RE: Evaluation of Alluvial aquifer background concentrations for Contaminants of Concern for the Homestake Mining Company Superfund Site (CERCLIS ID NMD007860935), Cibola County, New Mexico

Statistical Evaluation of Alluvial Groundwater Quality Upgradient of the Homestake Site Near Grants, New Mexico: Molybdenum, Selenium, Uranium

Reviewed by:
Richard J. Abitz
Geochemical Consulting Services, LLC
April 2009

Figure 1. Systematic grid and random points on a grid are the statistically valid methods for locating background wells.

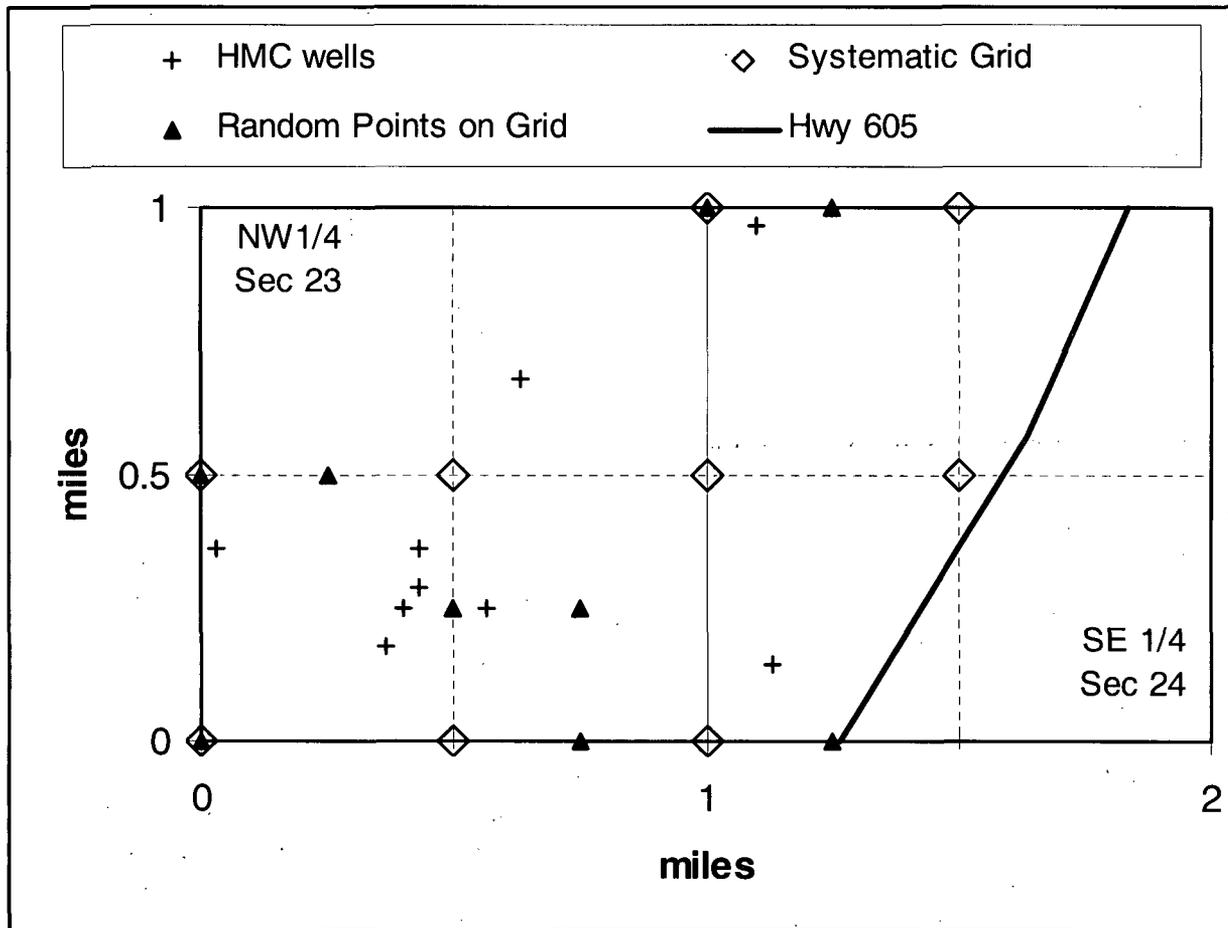
Figure 1 illustrates the location of HMC's near upgradient wells in Sections 23 and 24, relative to wells that are located on a systematic grid or as random points on a grid. Assuming that the nine HMC wells are the proper density over the given area, nine locations on a systematic ½ by ½ mile grid (open diamond symbols) or nine random locations selected from the nodes of a ¼ by ¼ mile grid (filled triangles) illustrate the proper statistical methods for locating background wells. There is no statistical justification for the location of the present HMC wells used in this study.

As noted above, upgradient wells cannot be used to determine background water quality because the alluvial aquifer has been contaminated by past mining operations. However, if the upgradient alluvial system were uncontaminated, background wells would have to be located using a systematic grid or random locations on a grid. This valid statistical approach should also be followed to determine the location of background wells downgradient of the HMC plumes.

Figure 2. Variation in uranium concentration at well DD over a 22 year period.

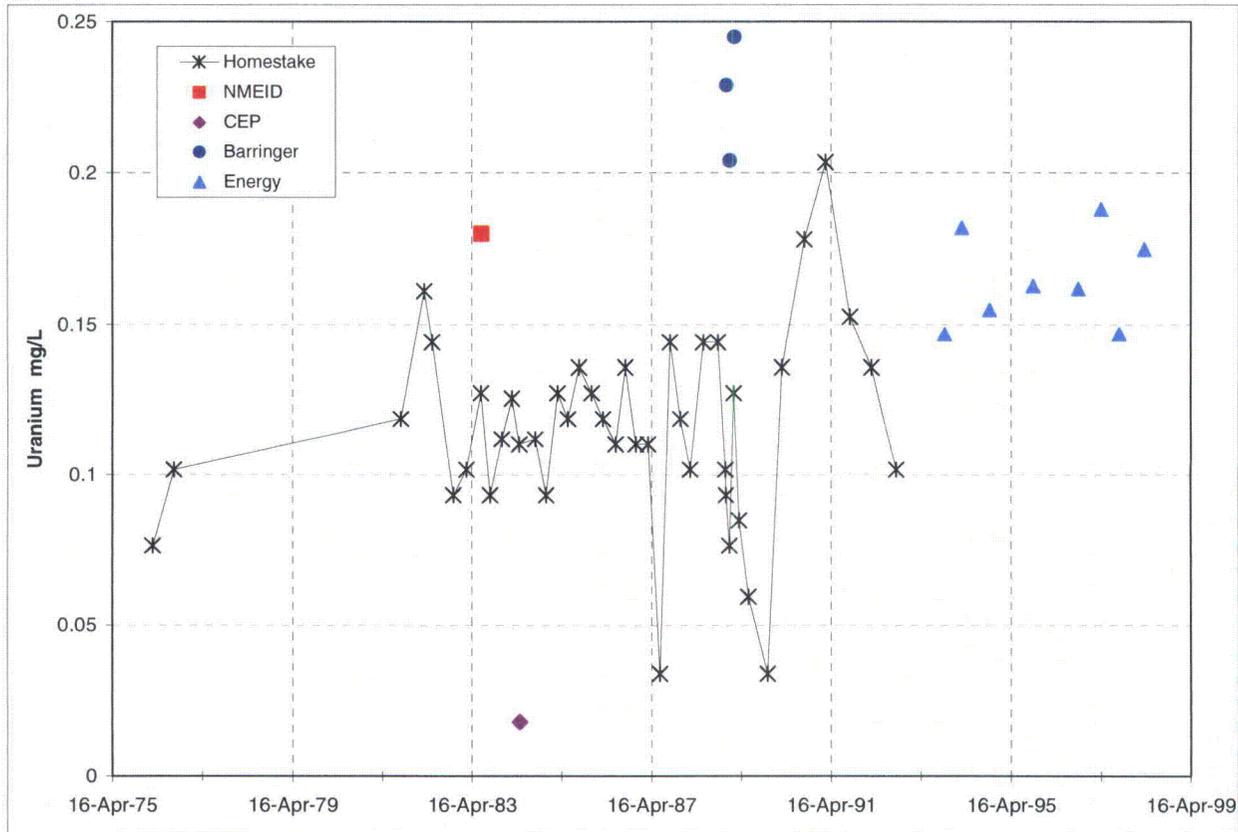
For example, at well DD, the 08Dec88 result for uranium is 0.102 mg/L, and this is followed by average values of 0.161, 0.140, and 0.186 mg/L for three rounds of split samples (13Dec88, 11Jan89, 15Feb89) and then back to 0.0848 mg/L on 29Mar89 (see Table 75, page 172 of the ERG report). Averaging the split samples from Homestake and Barringer produces results that are 60 to 100 percent greater than the single results that bracket the split samples. The gross difference in the Homestake and Barringer split results, as well as differences between Homestake, NMEID and CEP, are shown on Figure 2.

Additionally, there is a noted change in the uranium concentration at well DD on 21Oct93, and this reflects a change in the analytical laboratory (Homestake before 21Oct93 and Energy Laboratory on 21Oct93 through 1Apr98). Figure 2 illustrates that prior to 21Oct93, only 4 samples exceeded 0.147 mg/L, whereas after this date all samples are above this value. This shift in values could reflect methods and equipment at different laboratories or it may indicate the arrival of additional contamination at the well. Although the large swing in values reported by Homestake Laboratory over the period 16Apr89 through 16Apr93 suggests analytical and/or sampling problems.

Failure to discuss the laboratory QA/QC leaves a large void in the data interpretation of split-sample results that are significantly different. Which laboratory is reporting the result that is closest to the true value?
